To: T10 Technical Committee
From: Ed D'Avignon, Vitesse Semiconductor (davignon@vitesse.com) and Rob Elliott, HP (elliott@hp.com)
Date: 18 April 2006
Subject: 06-177r1 SAS-2 ZONED BROADCAST processing clarification

Overview

Figure 1 — ZPSDS attached to SAS-1/SAS-1.1 expanders outside the ZPSDS

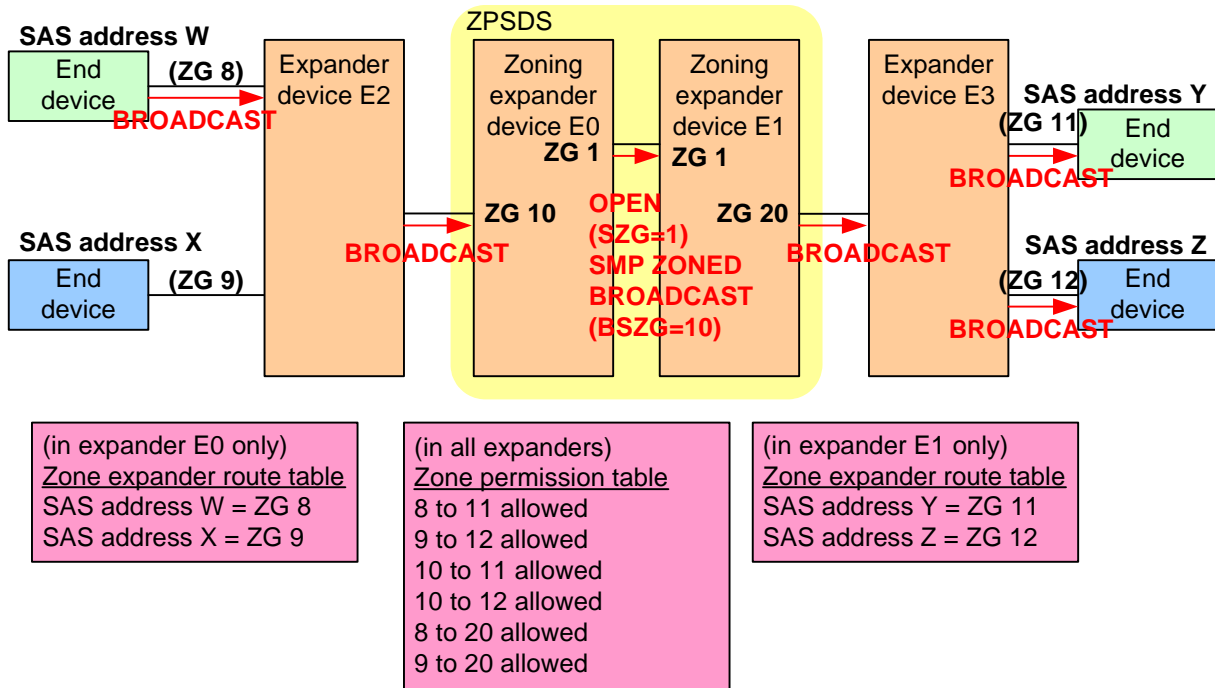
With legacy expanders outside the ZPSDS that only understand BROADCAST primitives:

If “new” expanders outside the ZPSDS understand the SMP ZONED BROADCAST request, they can partially participate in zoning (while still being considered outside the ZPSDS):

- a) from outside the ZPSDS includes source zone groups and/or source SAS address(es)
- b) inside the ZPSDS includes source zone groups and/or the source SAS address(es)
- c) to outside the ZPSDS includes source zone groups and/or destination source SAS address(es)

Figure 2 — ZPSDS attached to SAS-2 expanders outside the ZPSDS

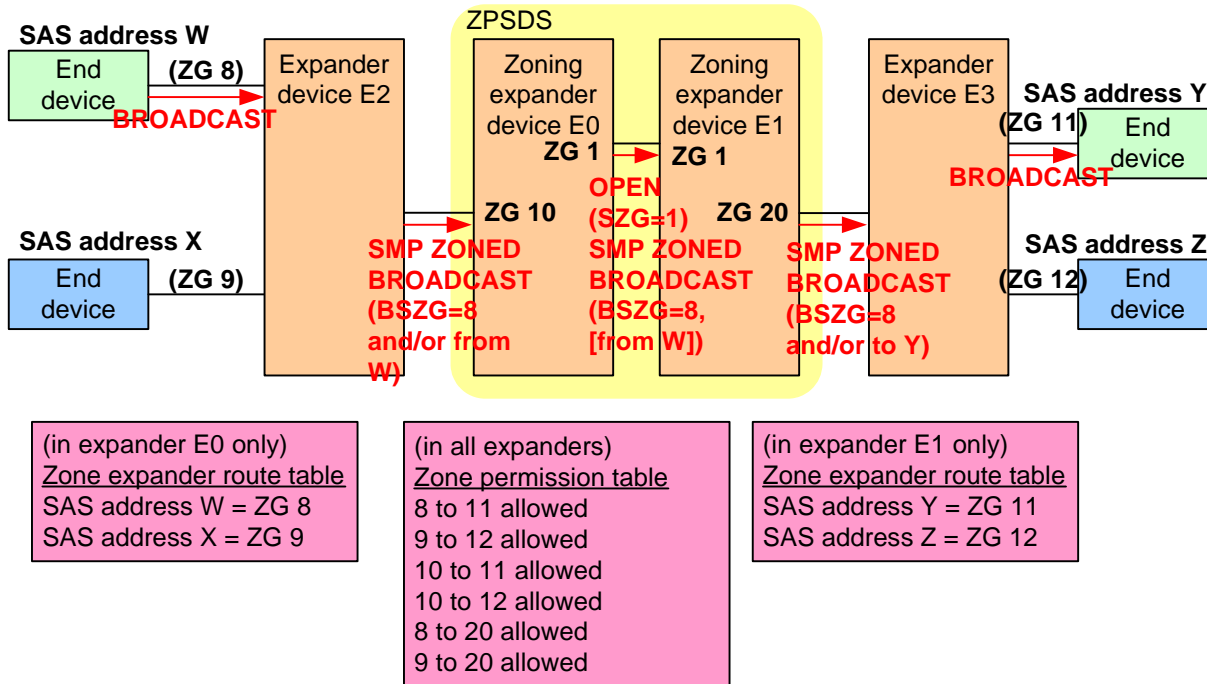
If “new” expanders outside the ZPSDS understand the SMP ZONED BROADCAST request, they can partially participate in zoning (while still being considered outside the ZPSDS):

- a) from outside the ZPSDS includes source zone groups and/or source SAS address(es)
- b) inside the ZPSDS includes source zone groups and/or the source SAS address(es)
- c) to outside the ZPSDS includes source zone groups and/or destination source SAS address(es)

They could have zone permission tables and phy zone information and work from the SZG in the ZONED BROADCAST request, or the ZPSDS ingress boundary expander could translate between a source SAS addresses and their SZG, and the ZPSDS egress boundary expander could translate between the SZGs and the destination SAS addresses.

Editor’s Note 1: Discussion of those figures may result in ZONED BROADCAST carrying more than just a list of source zone groups
